UNITED STATES
NUCLEAR REGULATORY COMMISSION
REGION V

Title

Concern #129

Improper activities related to Pullman Welding.

2 PARTIAL DETAIL
006

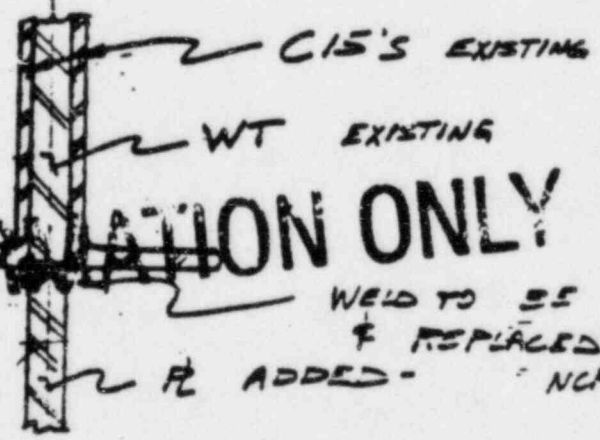
DUE TO WT BEING
 OUT FLUSH WITH
 BOTTOM OF CIS, WHEN
 REMOVING DEFECTIVE WELD
 METAL & REPLACING, WELD
 METAL WILL TIE CIS TO
 WT.

WELD TO BE REMOVED
& REPLACED PER
NCR 535-17-60

To F. M. Russell/P. Palomo Subject Repair per NCR 8833XR-60
From Dennis Humbert WR C-6180

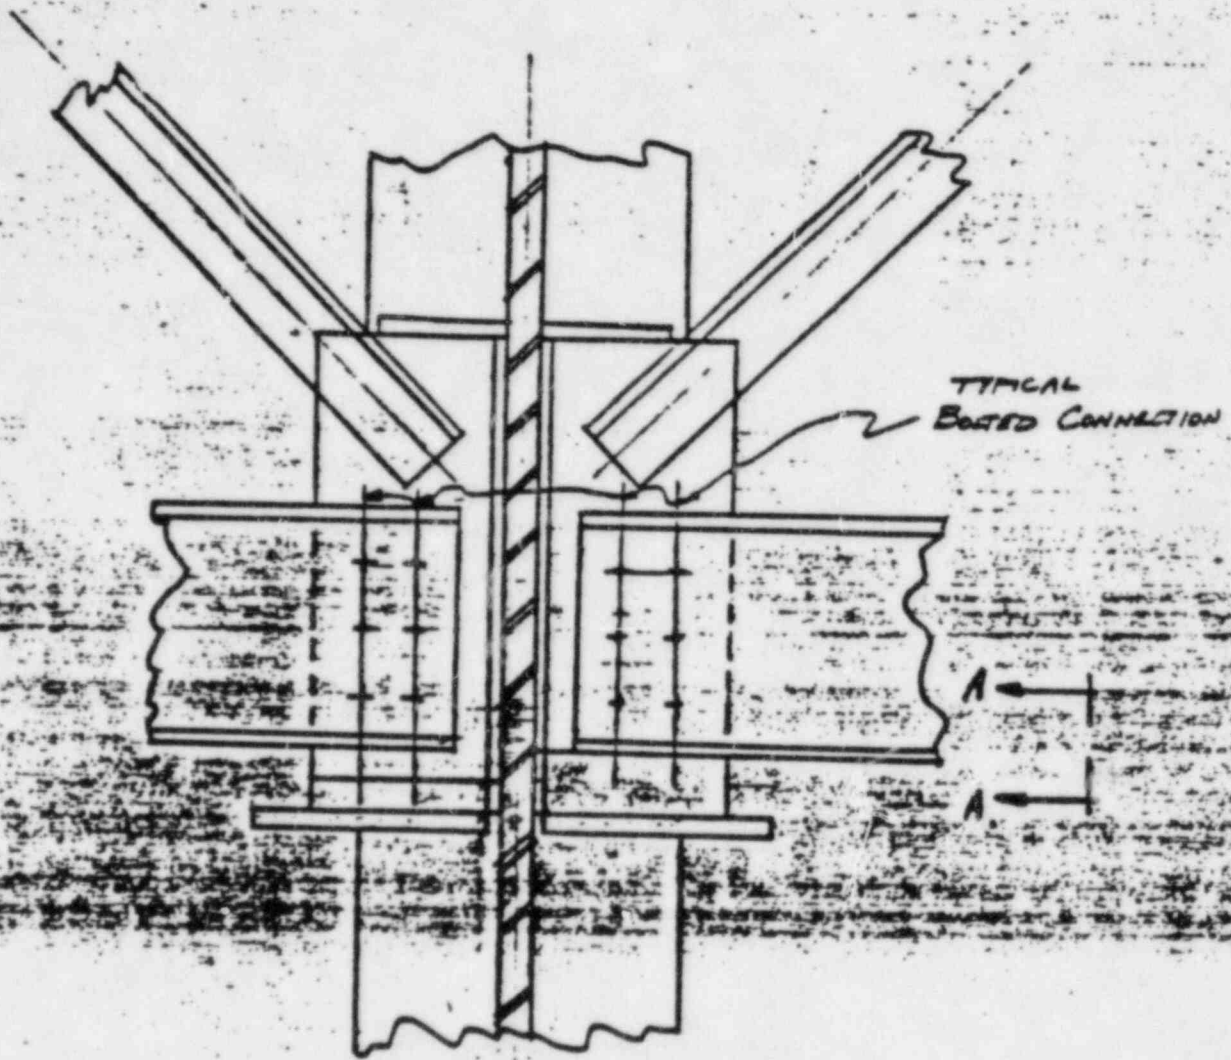
Problem Reference EDR 819. Some full Penetration welds detailed on dwgs.
6180-F1-13-006 & 007 have defects and require repair per NCR 8833XR-60. Some of these
welds that require repair are on plates that were raised in elevation per EDR 819.
Repair of these welds will cause C15 to be fused to these H'S & to existing WTs. Is this
condition acceptable? If this condition is not acceptable, please advise on how to
proceed.

Reply Not acceptable. Either install to prevent
fusion to channels or loose & spread channel
as required to prevent the fusion. Submit
proposed method for approval.
